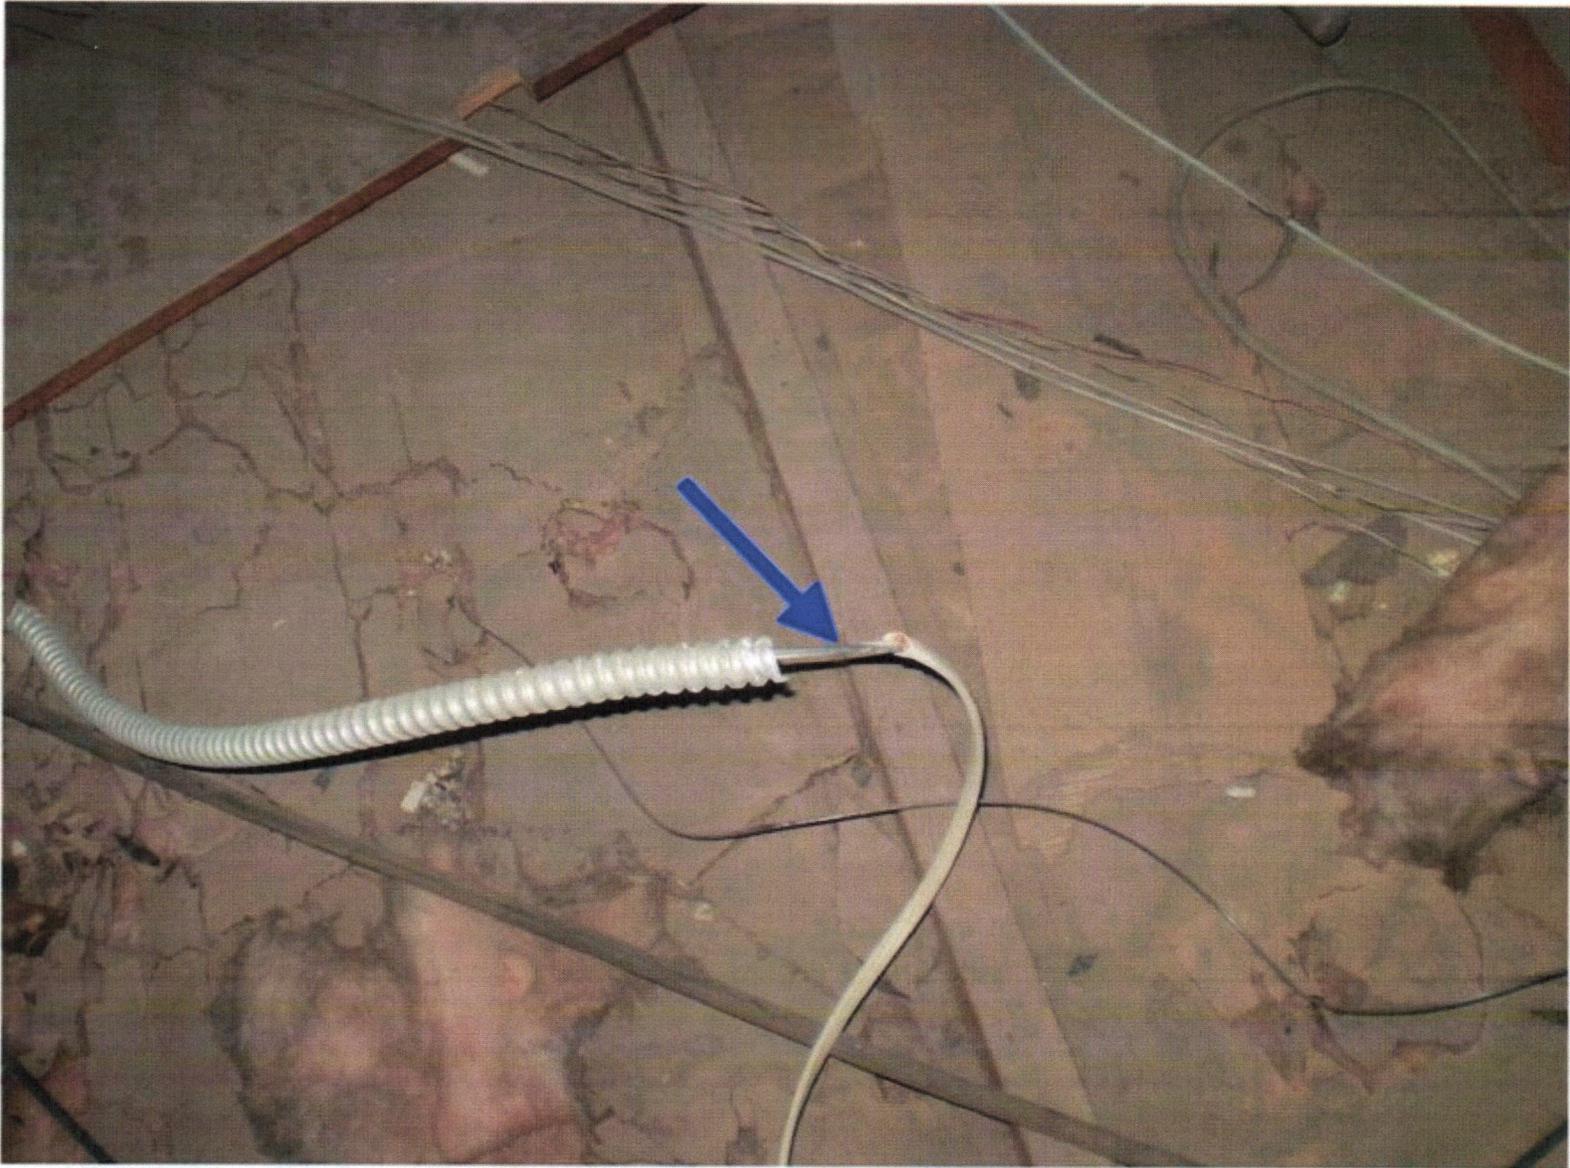
I saw some open electrical junction boxes in the attic. All junction boxes should have their covers in place to contain sparks should they occur.

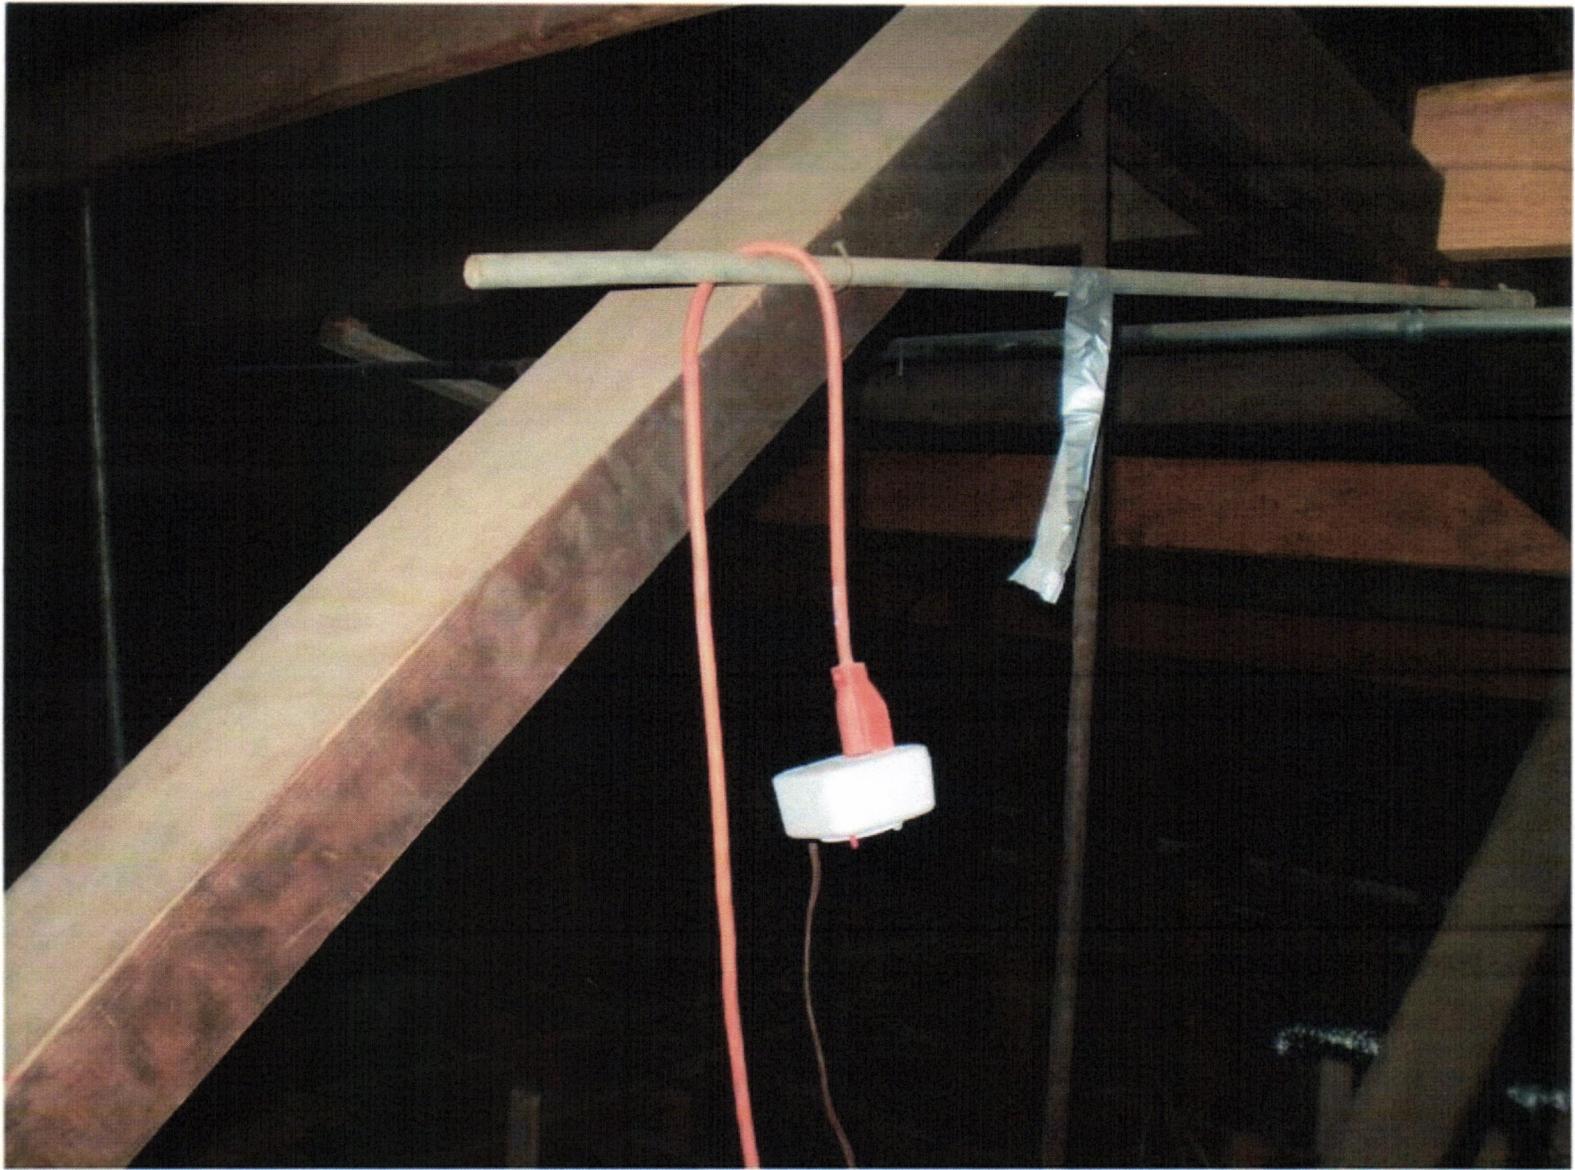
This flex conduit is not long enough to cover the wire where the sheathing has been stripped off. Aug 4, 2008 13:32

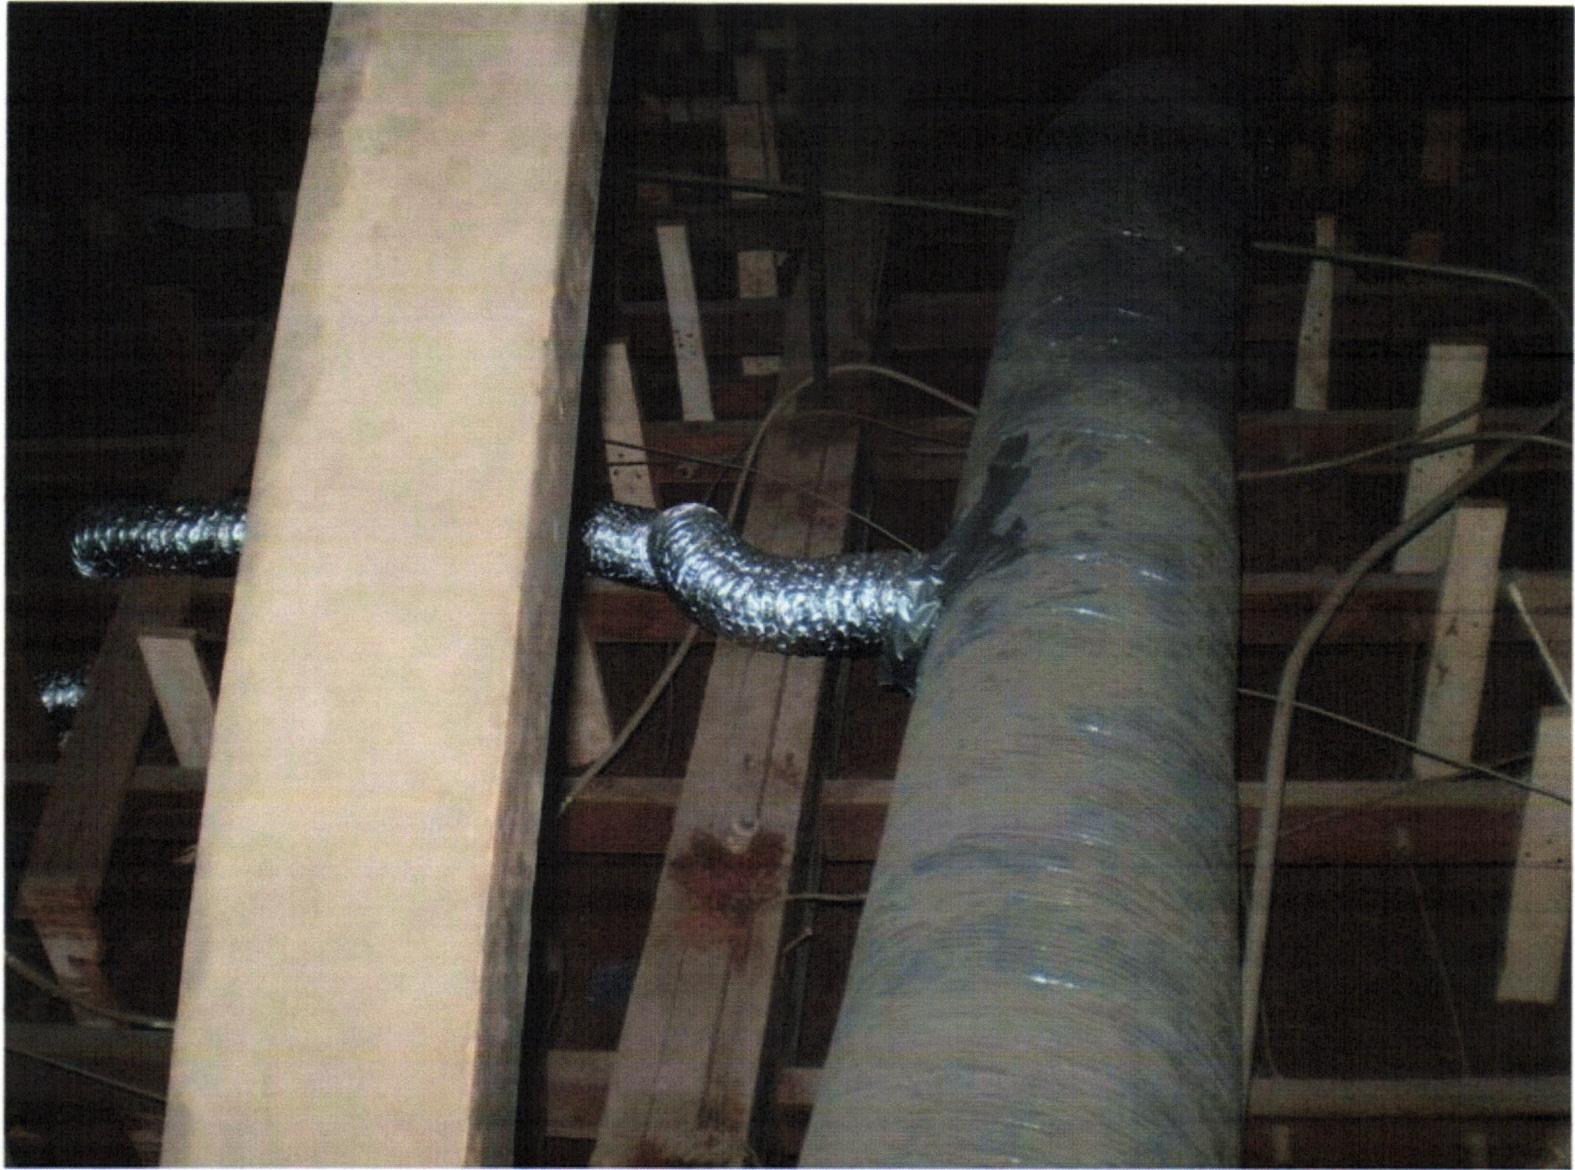
This is the vent (chimney) to the new furnace in the attic. Notice that the required one inch clearance was not provided between the vent and combustibles.
